TCEP Proj. #038-018-10

ADDENDUM NO. 1

NEBRASKA ARMY NATIONAL GUARD CATS FRONT GATE PROJECT

**CATS Front Gate Project
NEARNG Proj. #31090269**

C113

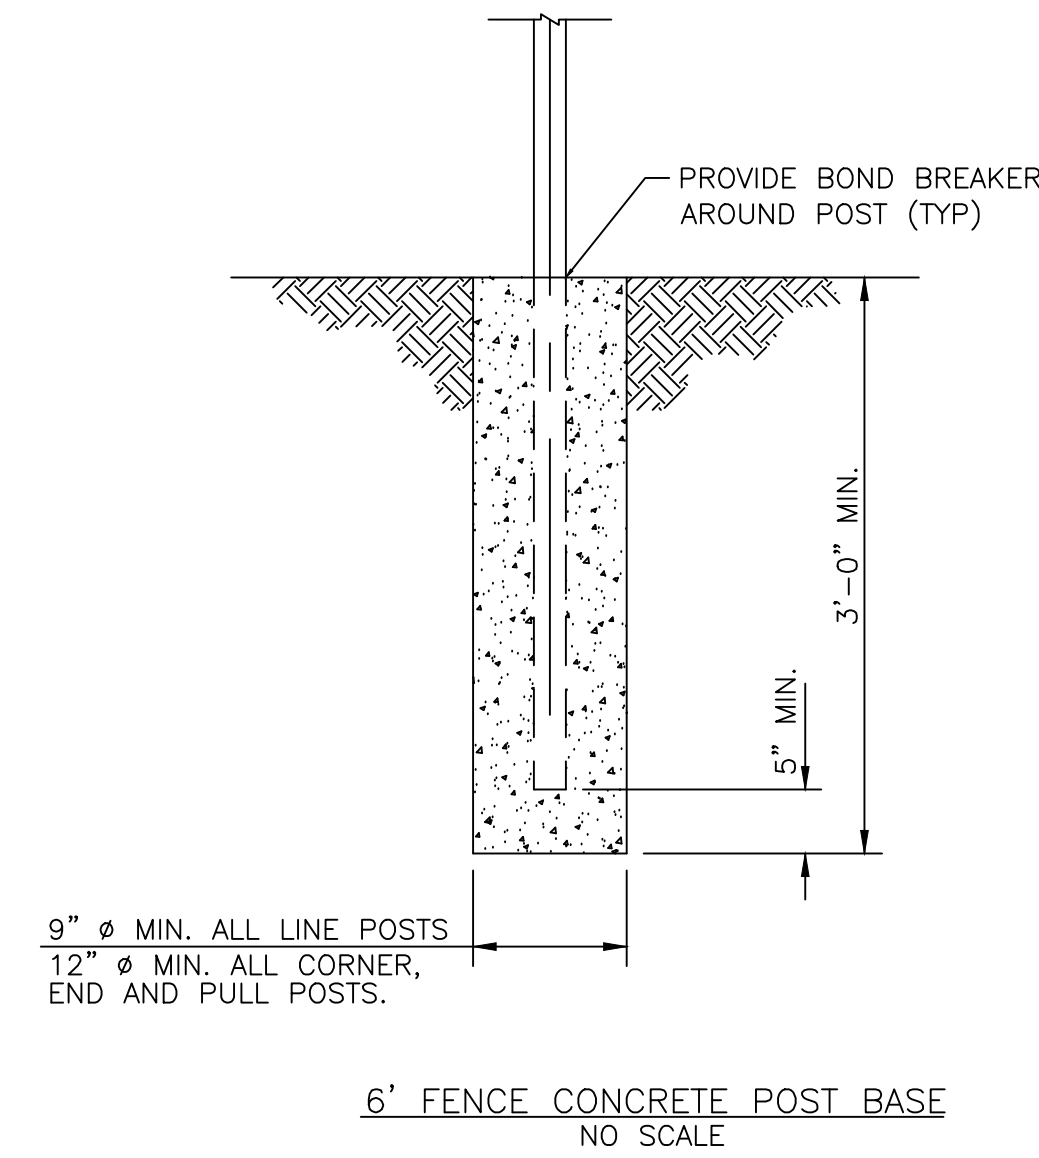
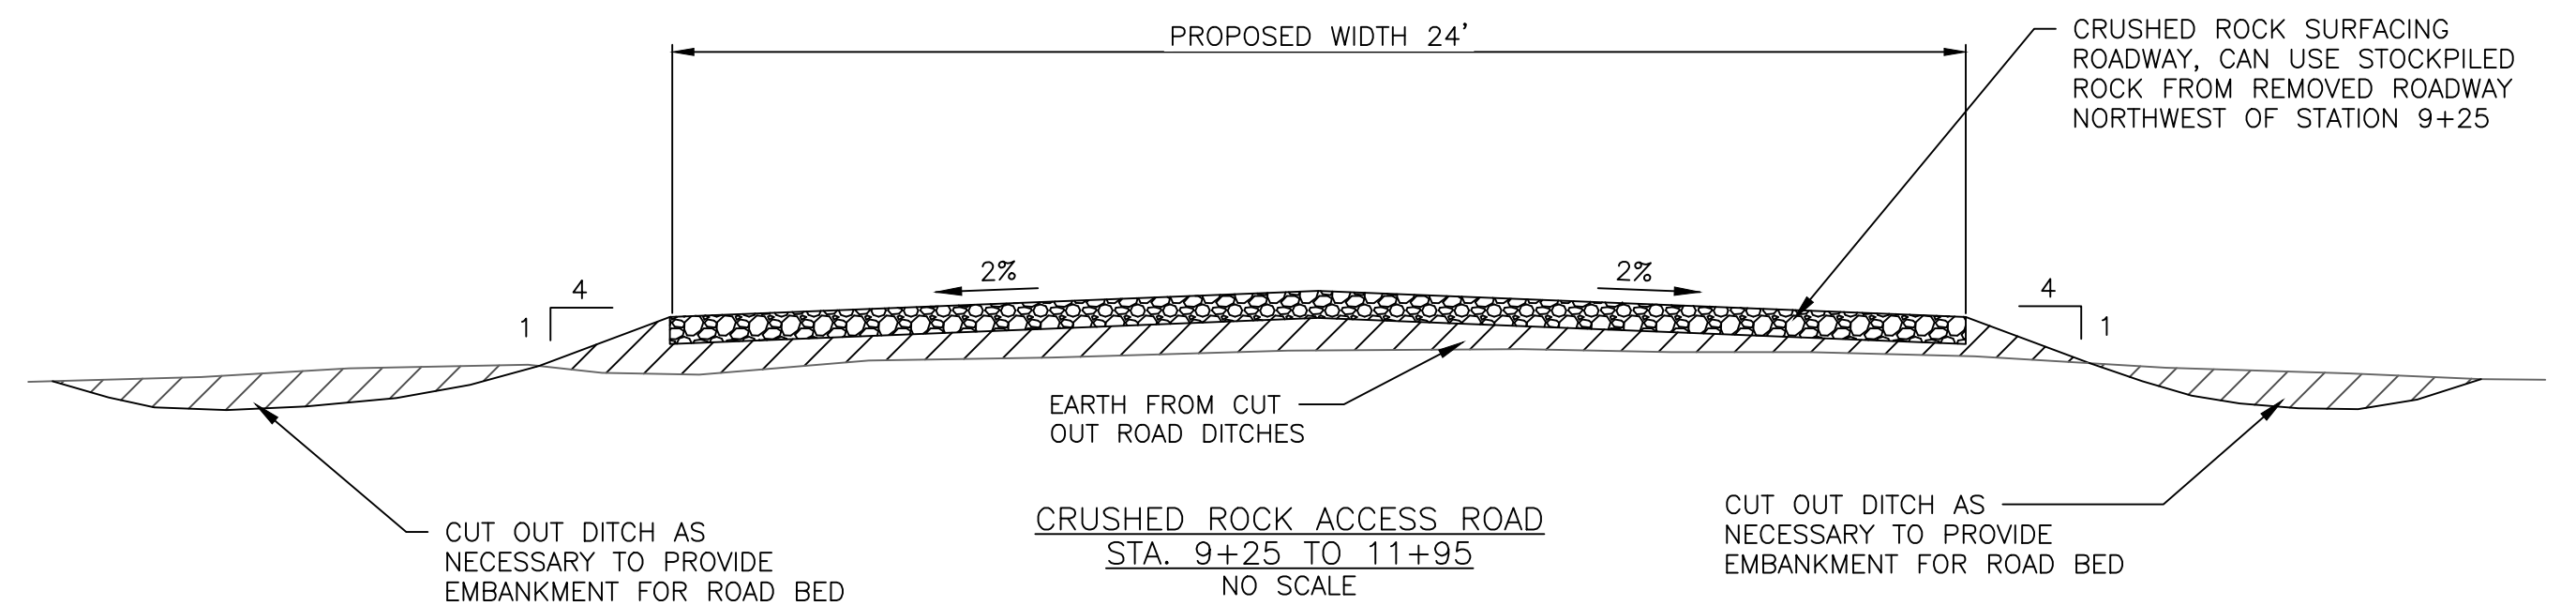
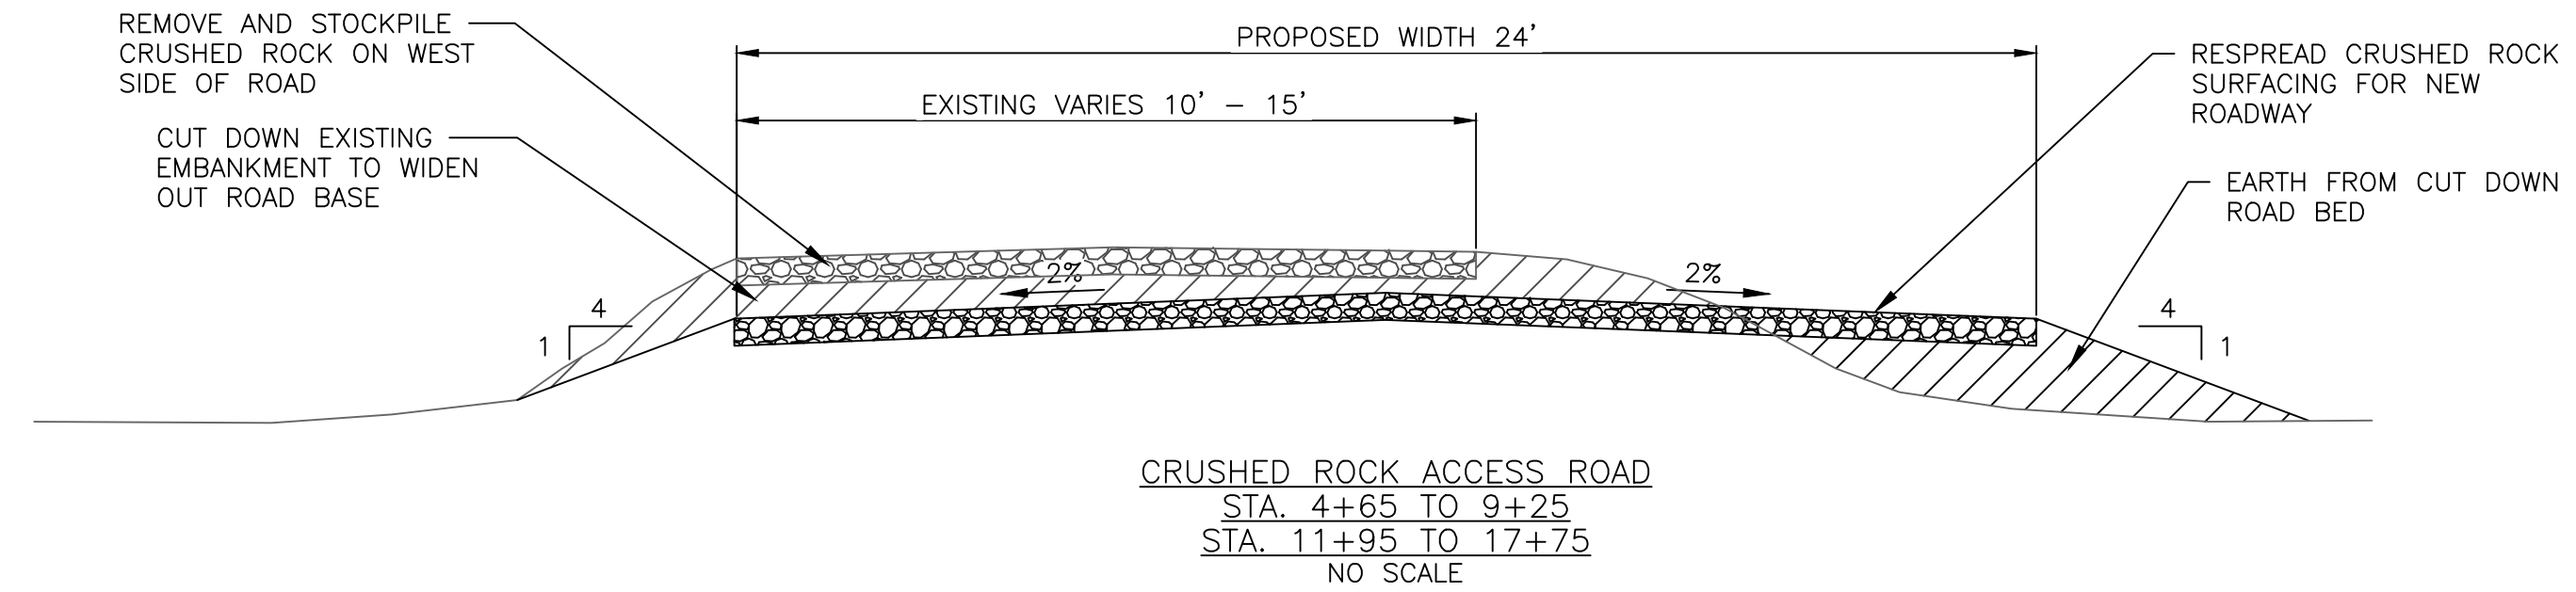
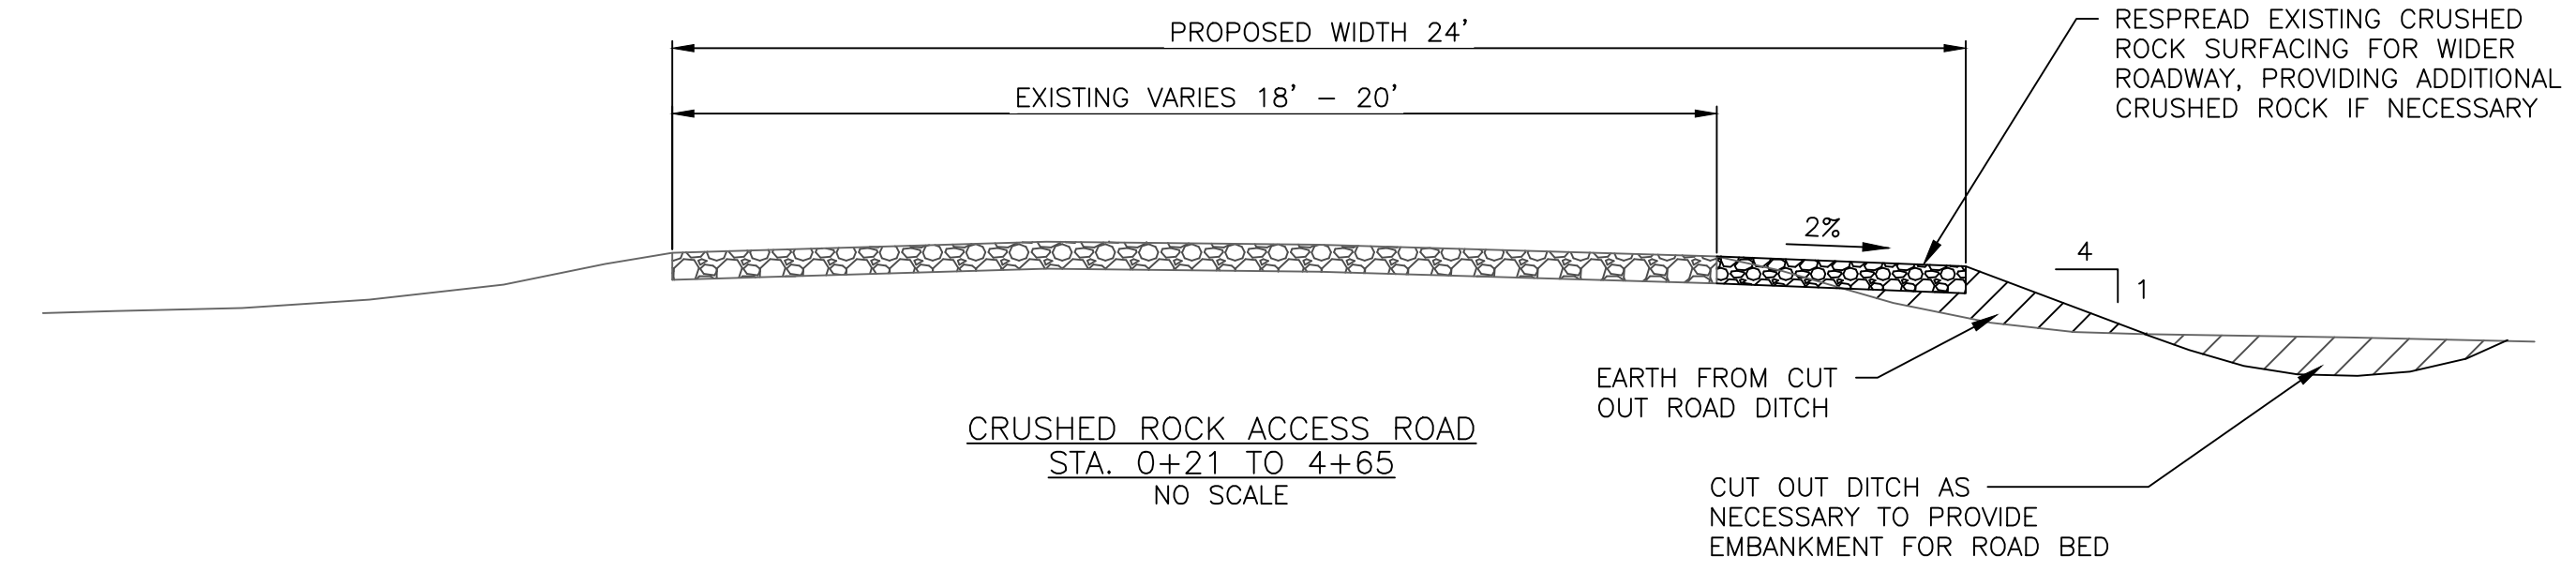
1. Add temporary access road and fence work as described on sheets C111 through C113.

Item 1-6: Add Sheets C111, C112, C113 and C114

Sheets C11, C112, C113 are issued for ABI 4, Sheet C114 is to be bid as part of the base bid.
